PLANNING BOARD APPLICATION

Re: Preliminary and Final Site Plan Review No. 1
Applicant: The Peddie School
Development: Athletic Center Solar
Block 53, Lot 1.02
Borough of Hightstown, Mercer County, New Jersey
Our File No.: HPB202202

Re: Preliminary and Final Site Plan Review No. 1
Applicant: The Peddie School
Development: Athletic Center Solar
Block 53, Lot 1.02
Borough of Hightstown, Mercer County, New Jersey
Our File No.: HPB202202

SHEET NAME:
CANOPY
ELEVATIONS

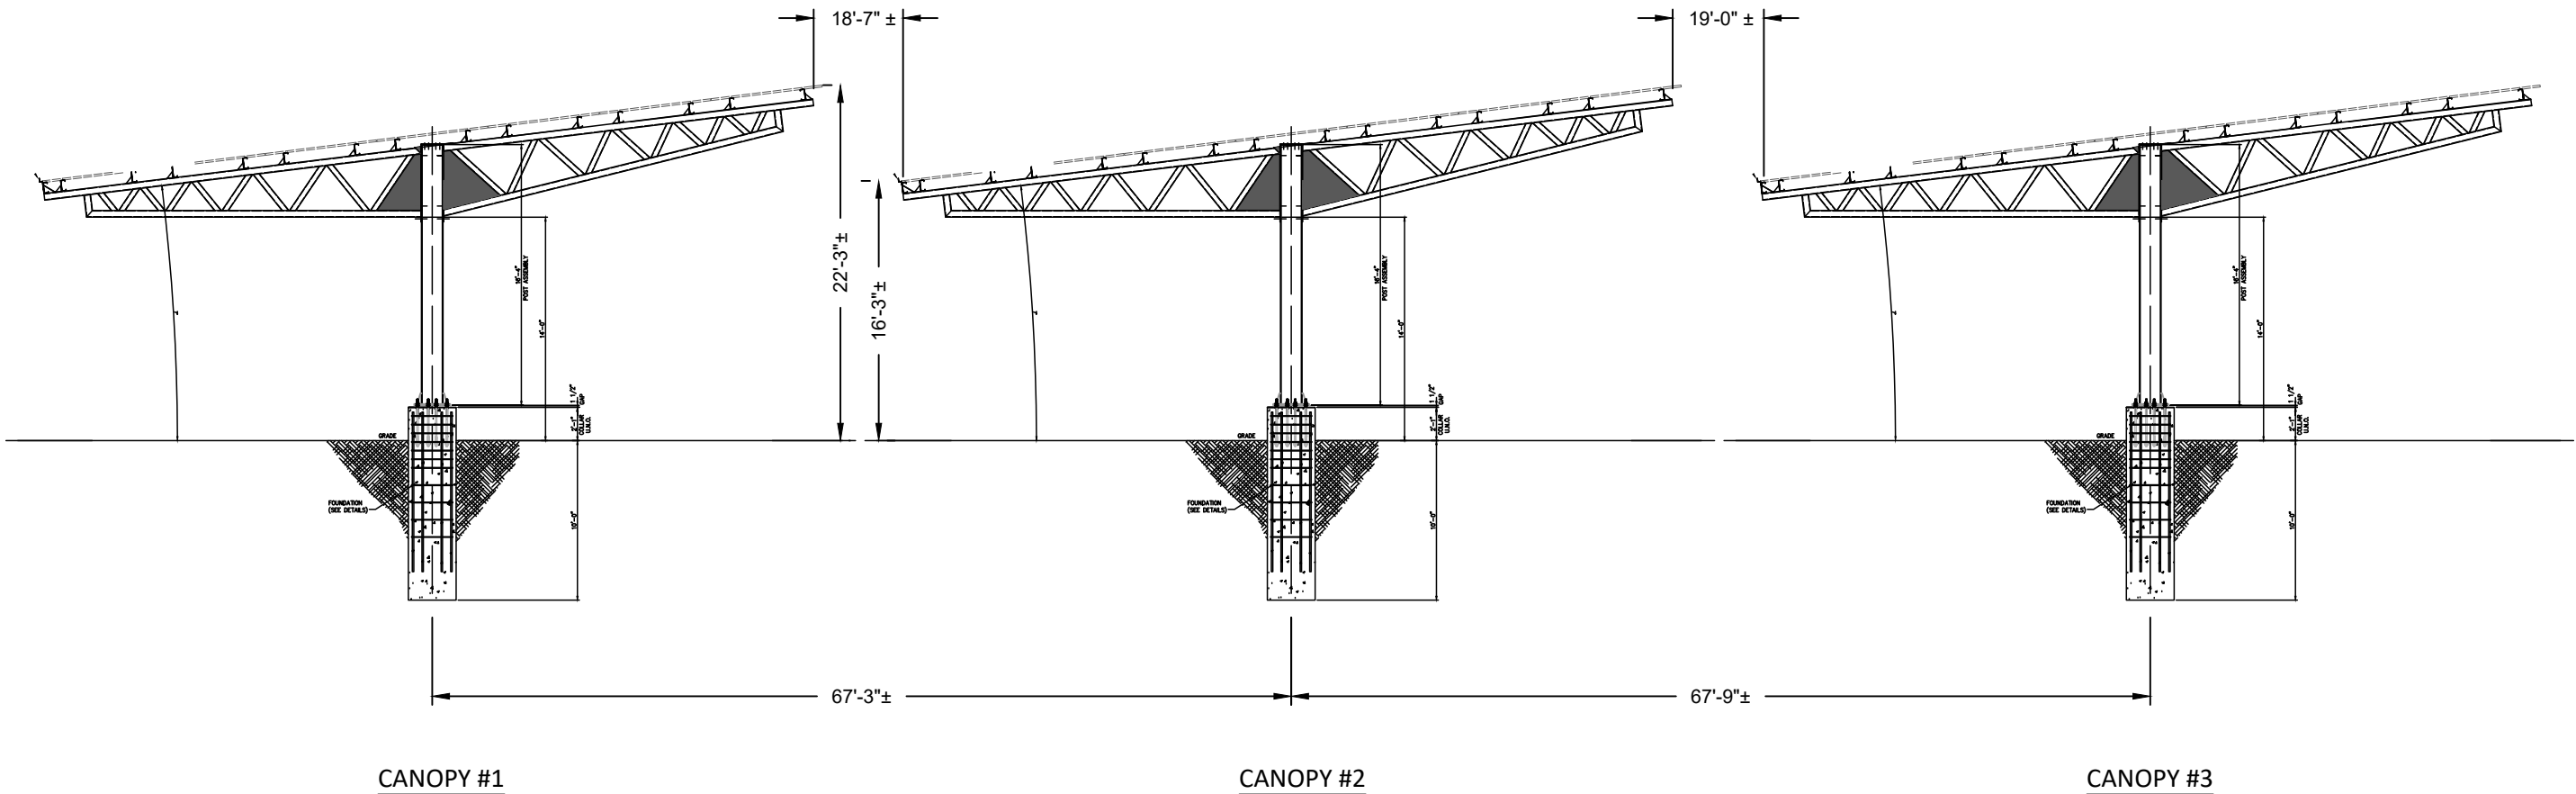
The Zoning R-1 table on Sheet 1, Cover Sheet indicates 23.75 feet (23'-9") and is noted as physical height + 2 ft.; however, there are inconsistencies on total height with other references, as shown on;

1. Dwg No. PV-200 by Ecogy Energy indicates a height of 22'-3" +/- feet to grade.
2. Dwg No. PV-202 by Ecogy Energy indicates a height of 21'-9" feet to grade.
3. Sheet 10, Details indicates a height of 21'-9" feet to grade.

Please clarify the total height and explain the note of "physical height + 2 feet."

COVER SHEET

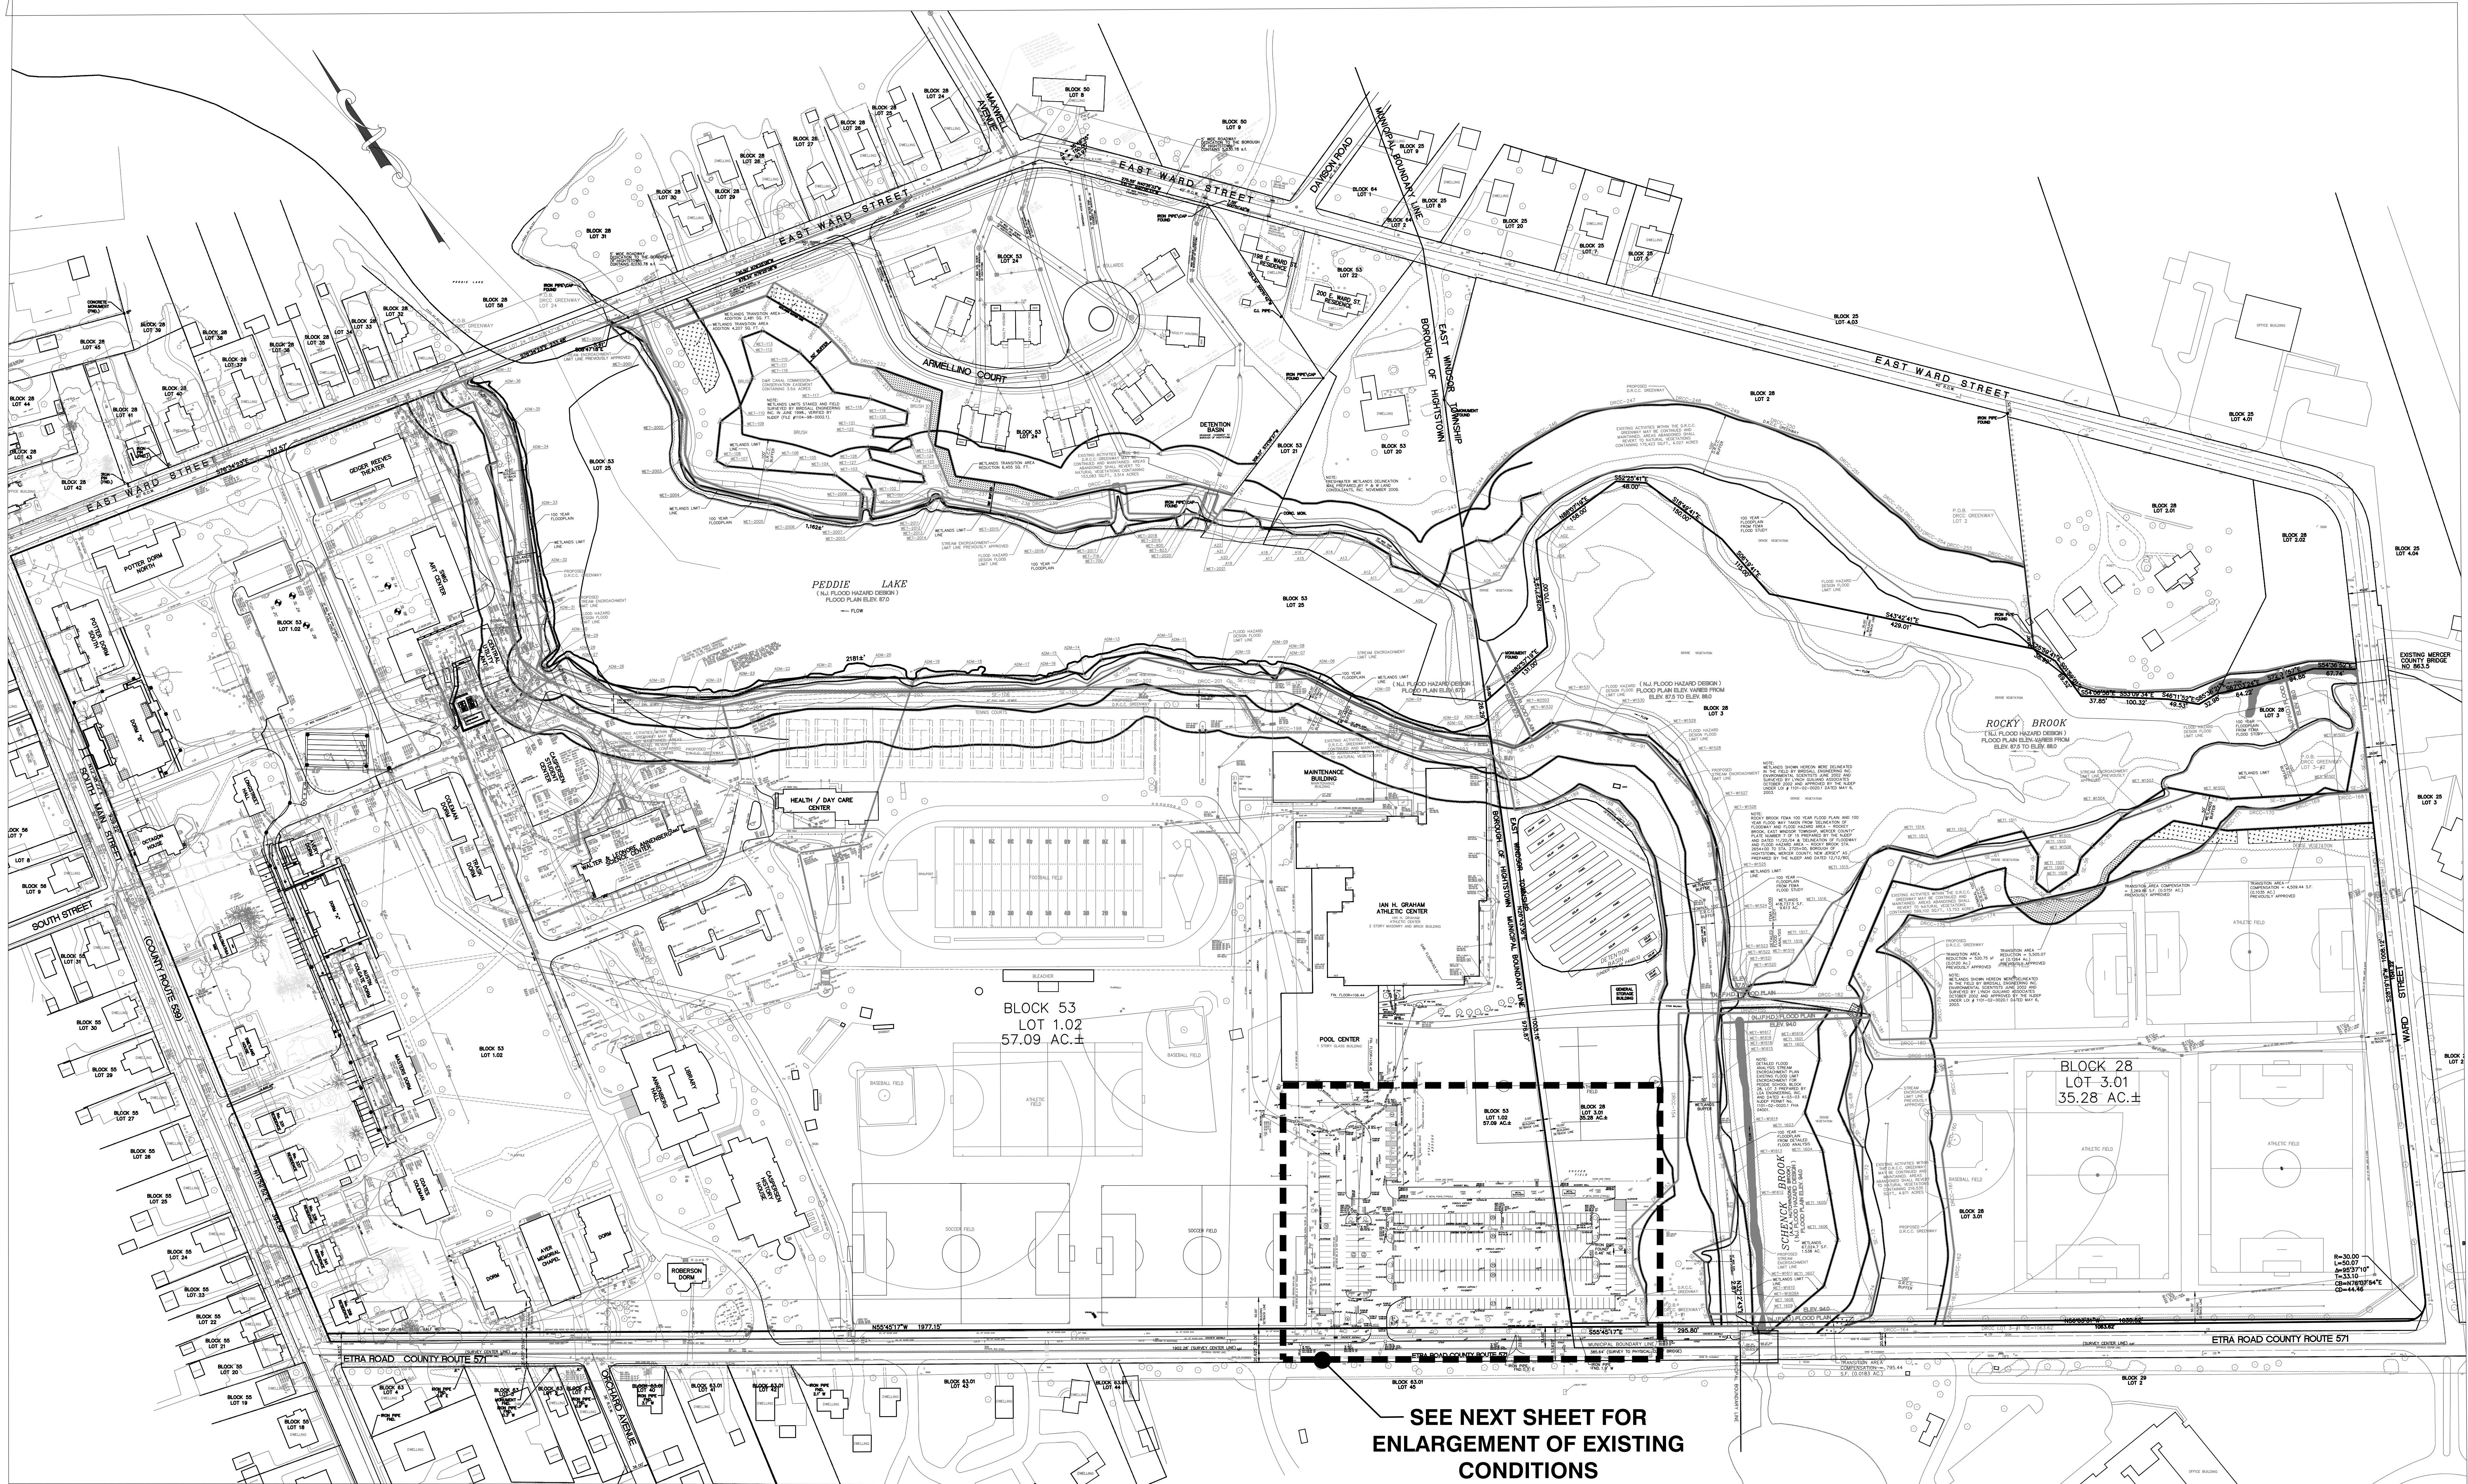
- b. The Applicant is reducing the existing number of parking spaces. There are presently 304 spaces including eight (8) handicapped parking spaces and 221 spaces are proposed including seven (7) handicapped spaces, as noted on Sheet 1, Cover Sheet. This is a reduction of 83 spaces. The

applicant is to provide testimony on why it is appropriate to reduce the number of parking spaces to such an extent. This is a reduction of 27% of the available parking.

- c. The Key Map, on the Cover Sheet is inconsistent with the list of owners for Blocks 56, 63 & 63.01. Please correct.
- d. The title of the Plan set is not consistent with the associated reports. Please assure all reports are consistently titled.
- e. Please place the "List of Owners," as shown on the Cover Sheet, for Hightstown and East Windsor, near their respective municipality's General Notes section.
- f. The Applicant is removing portions of standard pavement and portions of porous pavement and constructing a new parking lot with reconfigured pavement areas. Overall, the total existing standard pavement areas are being reduced and the porous pavement is being increased for the parking lot and driveway.

**PARTIAL EXISTING
CONDITIONS
PLAN**

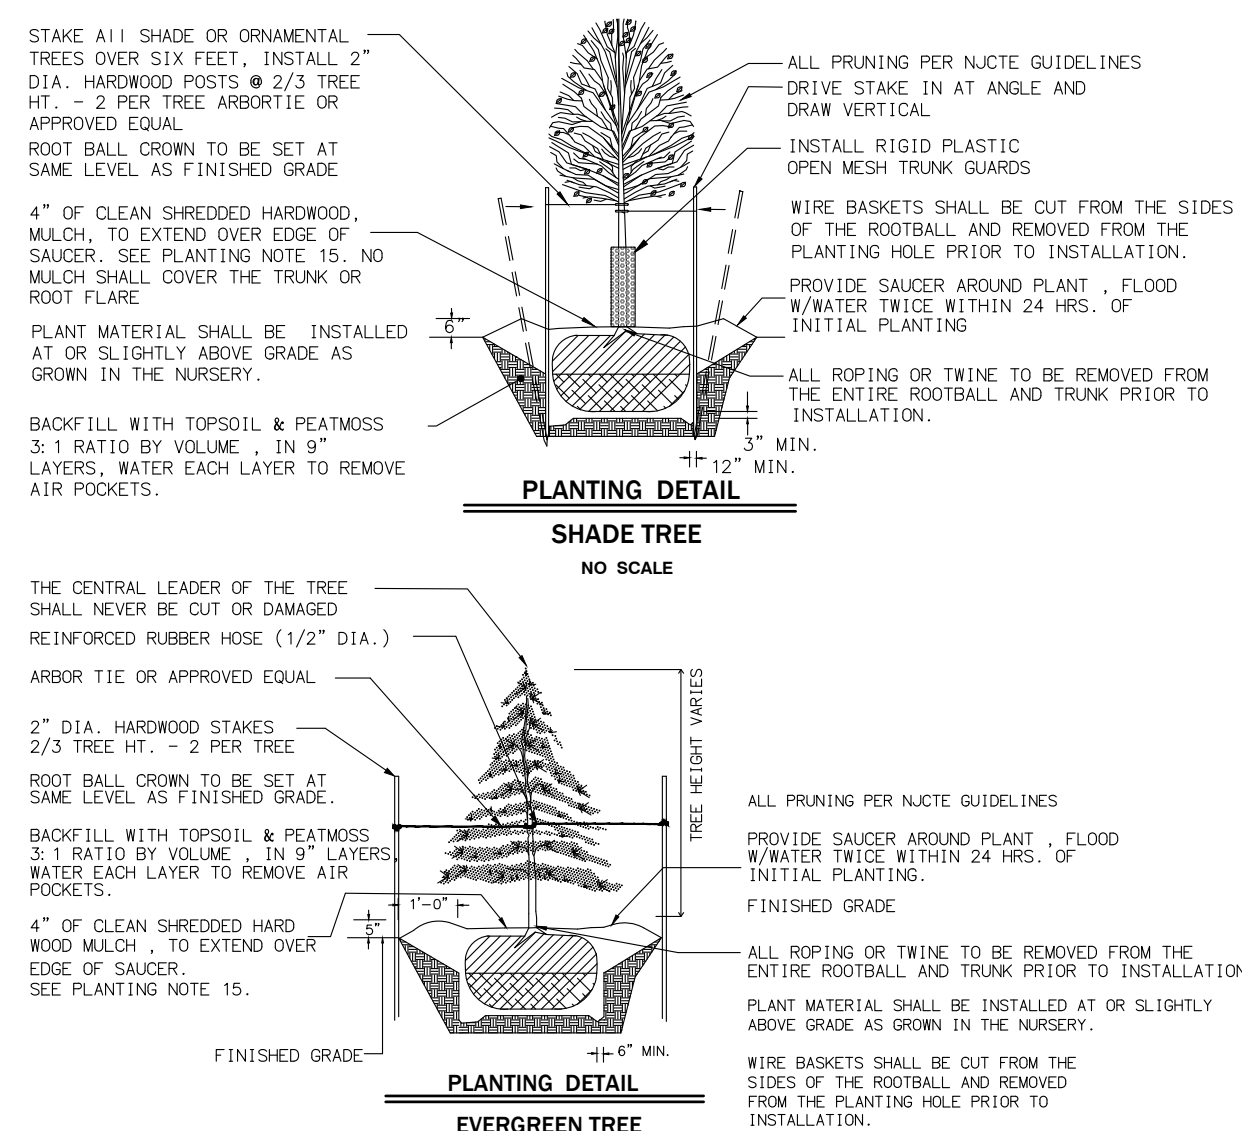
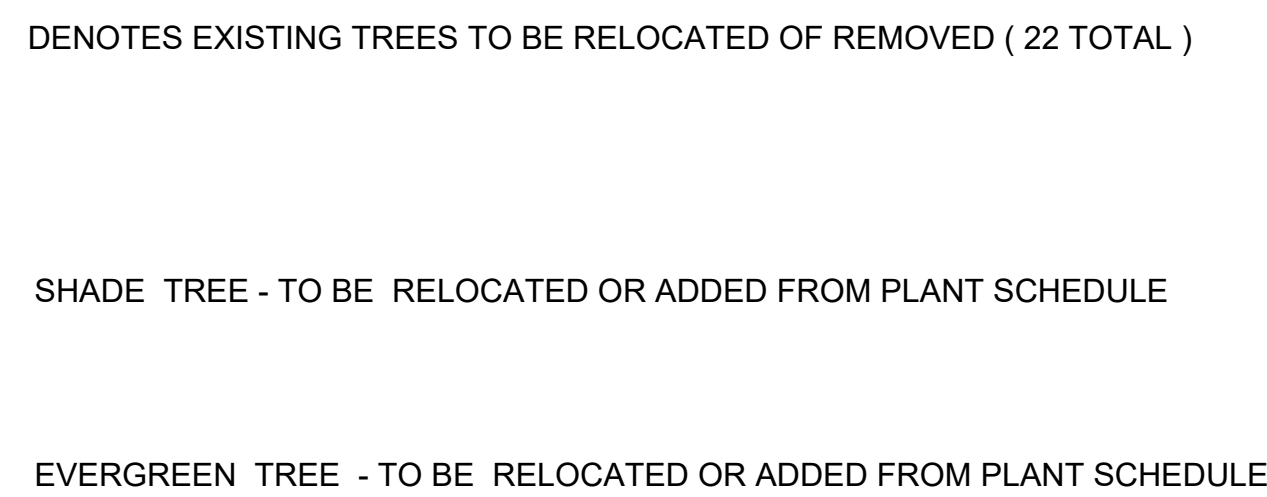
However, Sheet 3, Partial Existing Conditions Plan, indicates a total of 261 existing spaces of which 8 are handicapped spaces, and Sheet 5, Site Plan, indicates 238 proposed spaces of which 7 appear to be handicapped spaces.

There are inconsistencies in the total square footage for the existing porous and standard pavements versus what is proposed for porous and standard pavements. Discrepancies are found on the Cover Sheet; the Partial Existing Conditions Plan; the Site Plan; the Grading & Drainage Plan; and the Stormwater Management Report.
